# ADDENDUM 1

PROJECT NAME: **MARTIN LUTHER KING PARK**

DATE: 09/21/2016

PROJECT NO.: **40-00374**

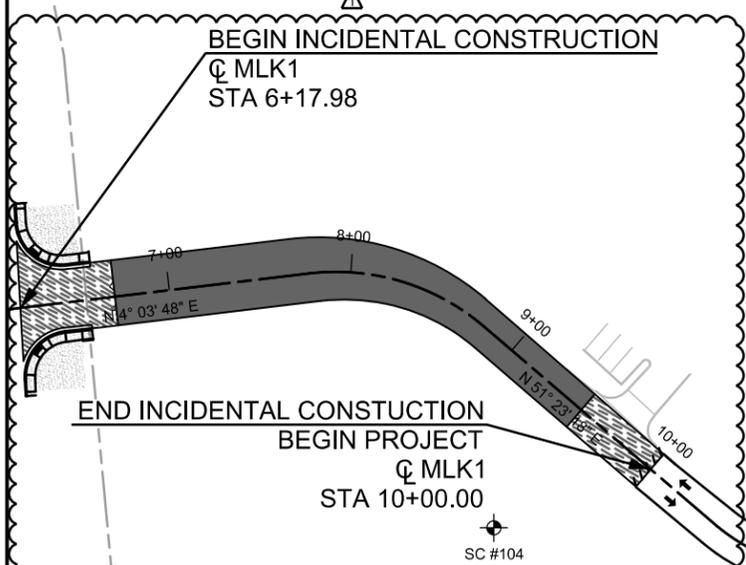
- c. Sheet 3 "PROJECT LAYOUT"
    - i. Added Incidental Construction Limits
    - ii. Added Notes No. 3 and No. 4
  - d. Sheet 9A "ROADWAY TYPICAL SECTIONS – ADDITIVE ALTERNATIVES NO. 2 & NO. 3"

ADDENDUM 1 (09-20-2016) - ADDED INCIDENTAL CONSTRUCTION LIMITS AND NOTES NO. 3 AND NO. 4

PROJECT No. 40-00374	DATE: SEPT 2016
DRWN BY: CC	DSGN BY: MGC
CHKD BY: JC	SHEET No. 9A

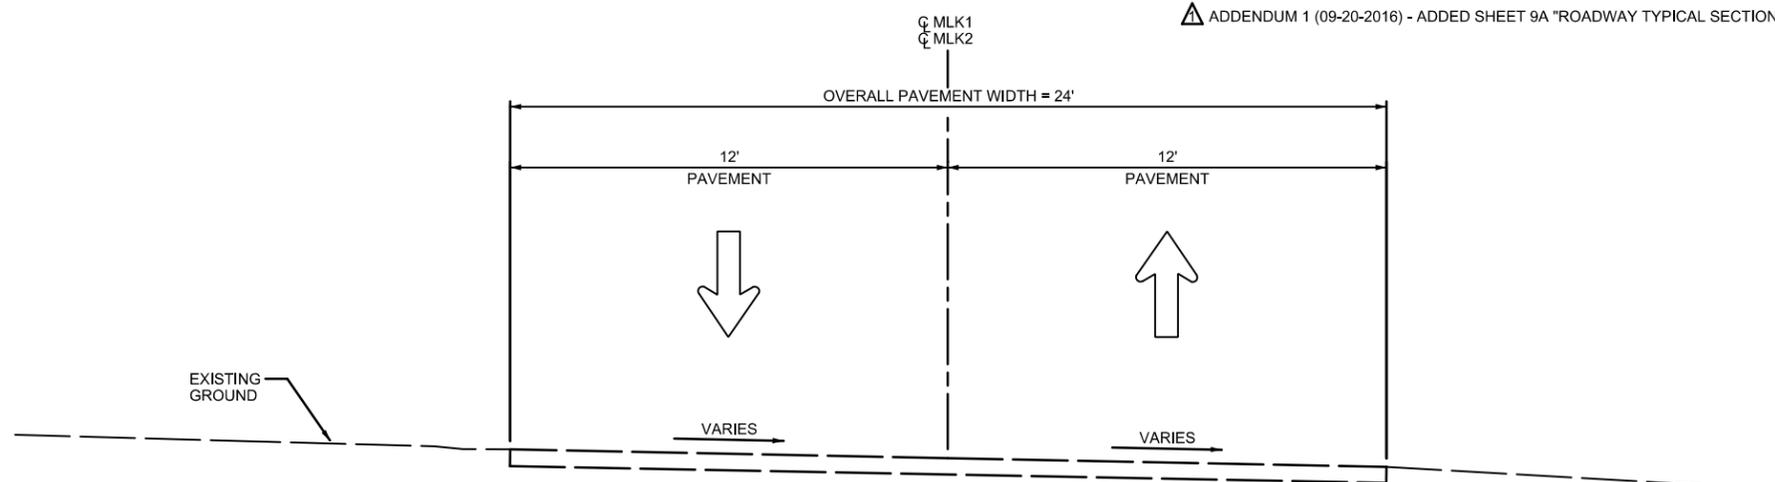
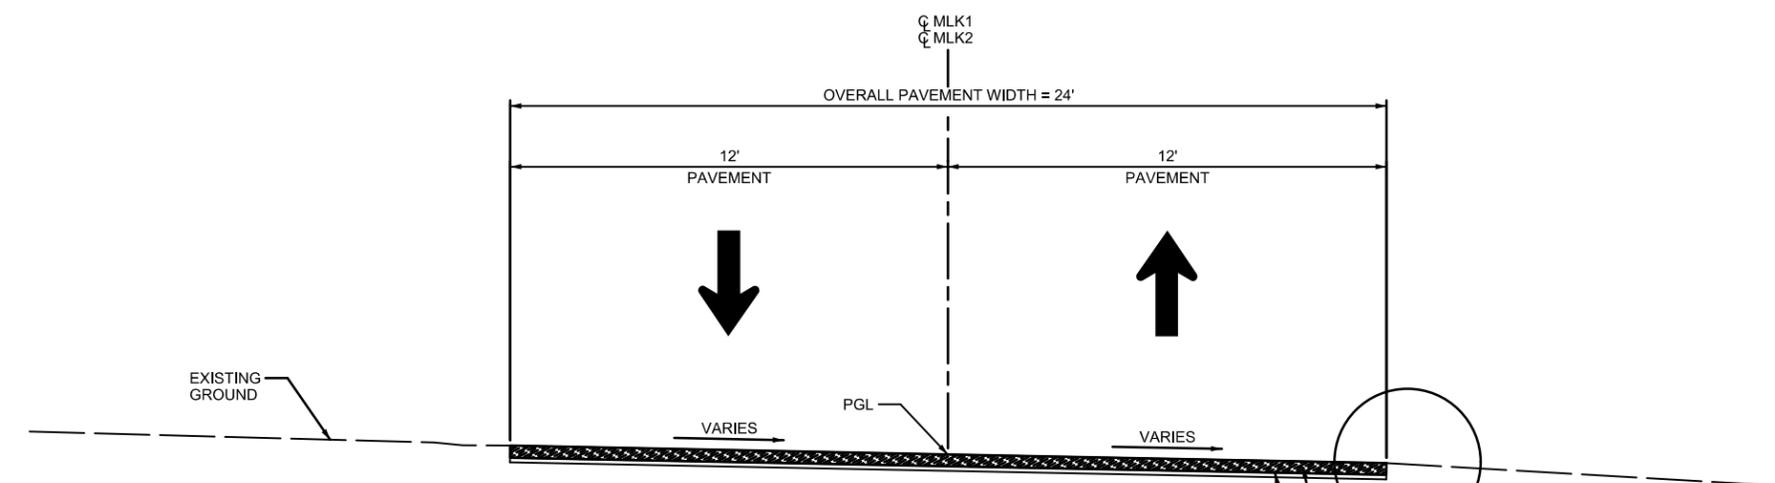
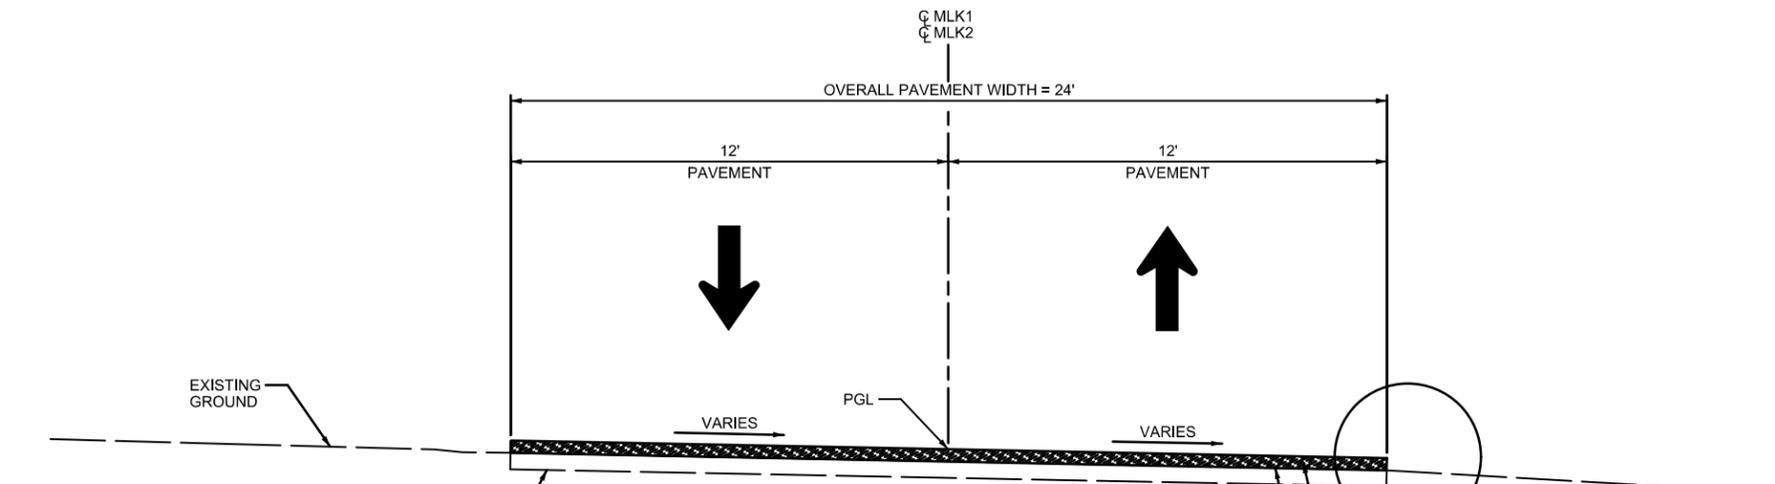
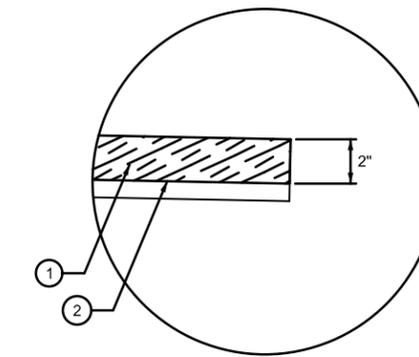
- i. Added Sheet 9A "ROADWAY TYPICAL SECTIONS – ADDITIVE ALTERNATIVES"
  - e. Sheet 10 "GENERAL NOTES"
    - i. Updated General Note No. 20
  - f. Sheet 13 "SUMMARY OF QUANTITIES (ROADWAY)"

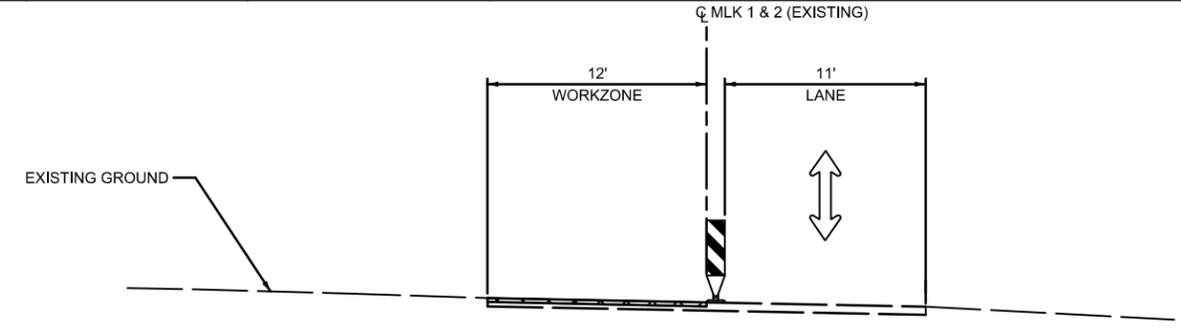
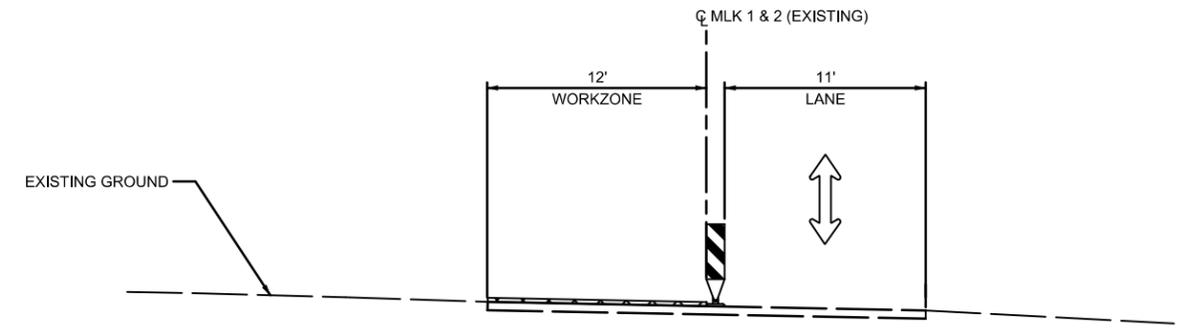
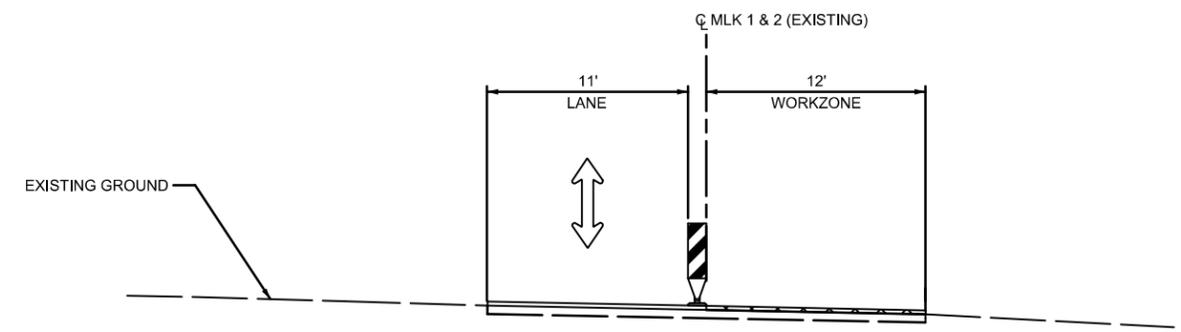
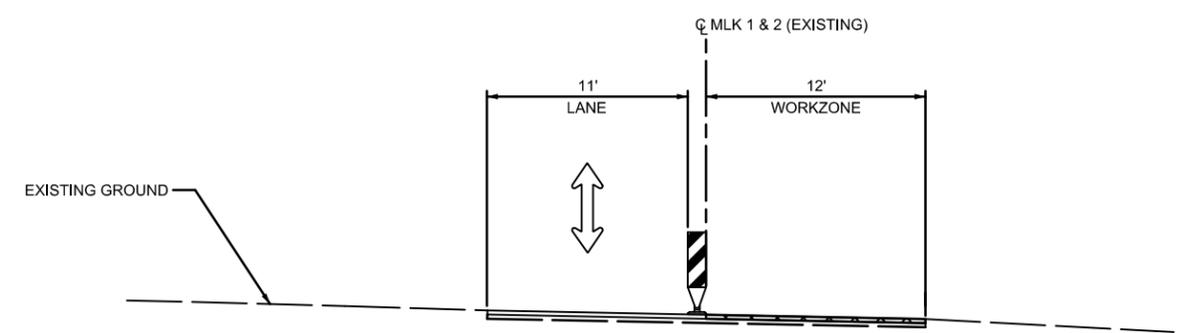
- j. Sheet 21A “TRAFFIC CONTROL PLAN – TYPICAL SECTIONS – ADDITIVE ALTERNATIVES NO. 2 & NO. 3”
  - i. Added sheet 21A “TRAFFIC CONTROL PLAN – TYPICAL SECTIONS – ADDITIVE ALTERNATIVES NO. 2 & NO. 3”

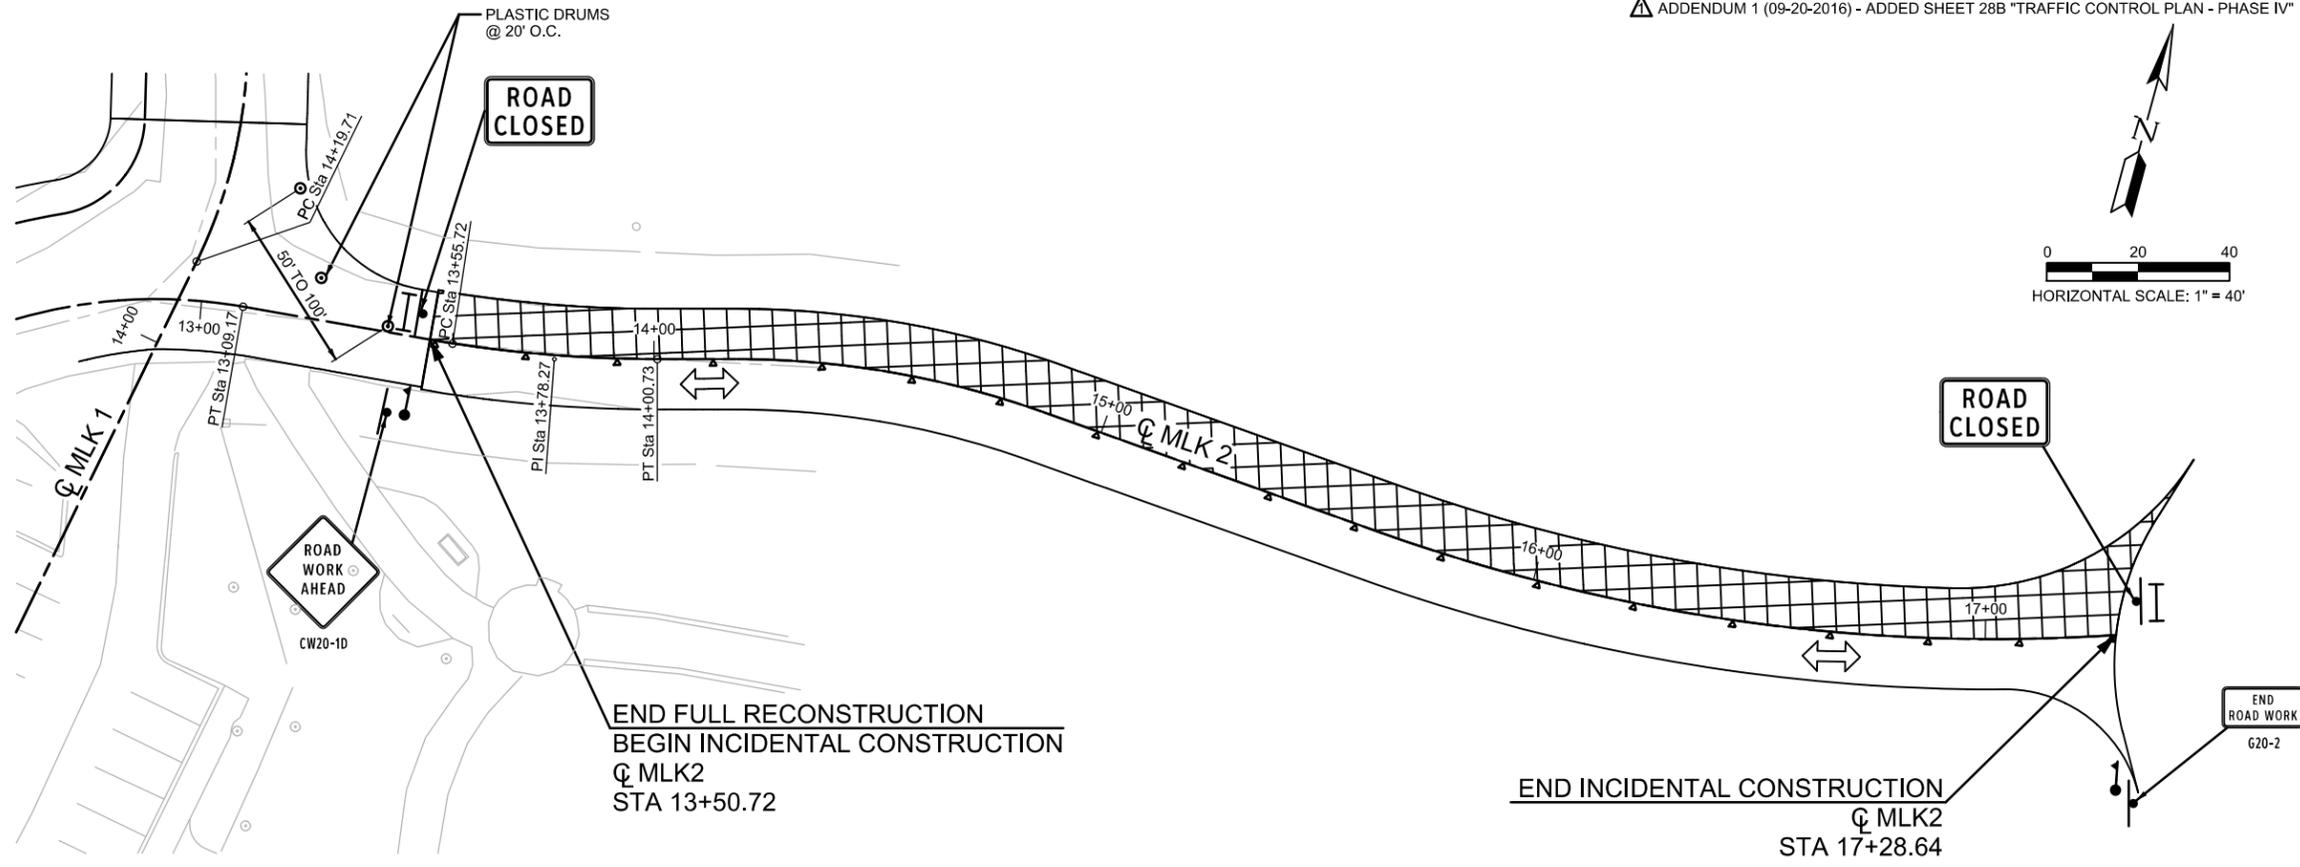
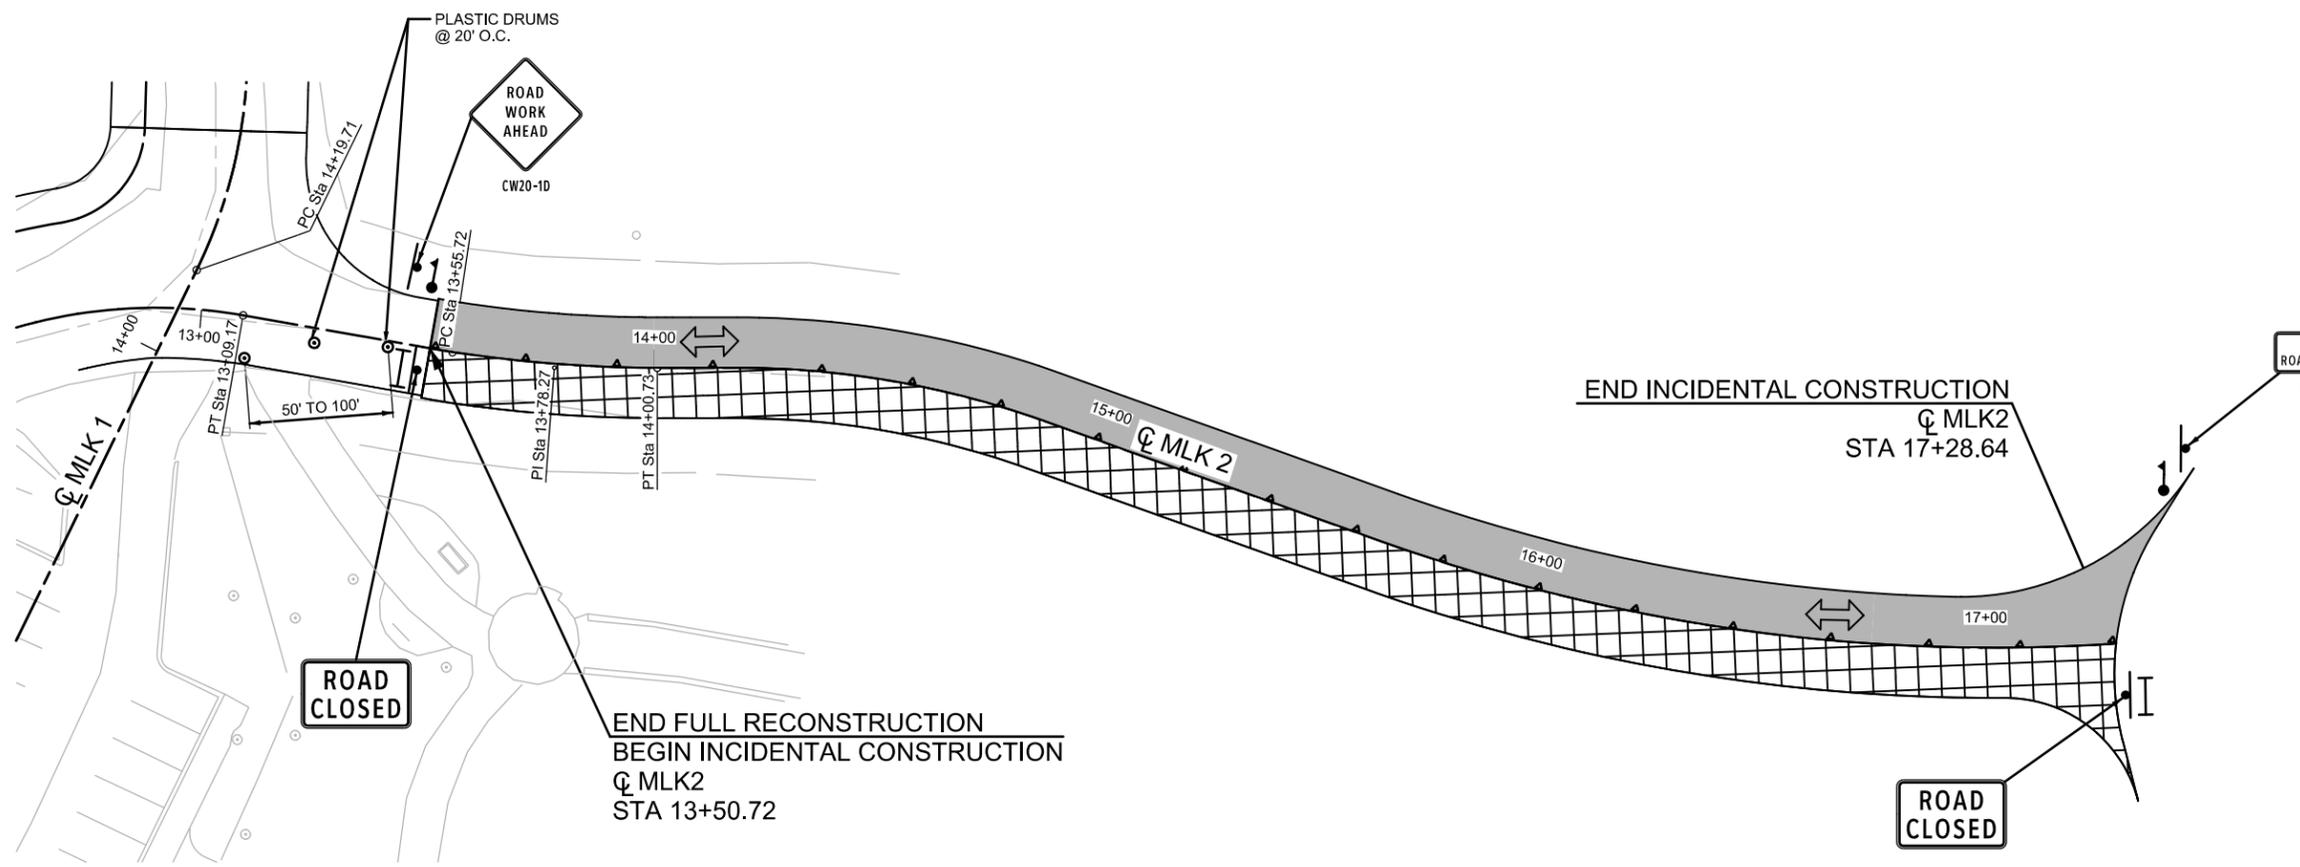
- i. Added sheet 28B “TRAFFIC CONTROL PLAN – PHASE IV”
- m. Sheets 38 – 40 “HORIZONTAL DATA CONTROL SHEET”
  - i. Added horizontal chain extension for MLK 2 centerline and reformatted all sheets

ADDENDUM 1 (09-20-2016) - ADDED SHEET 28B "TRAFFIC CONTROL PLAN - PHASE IV"
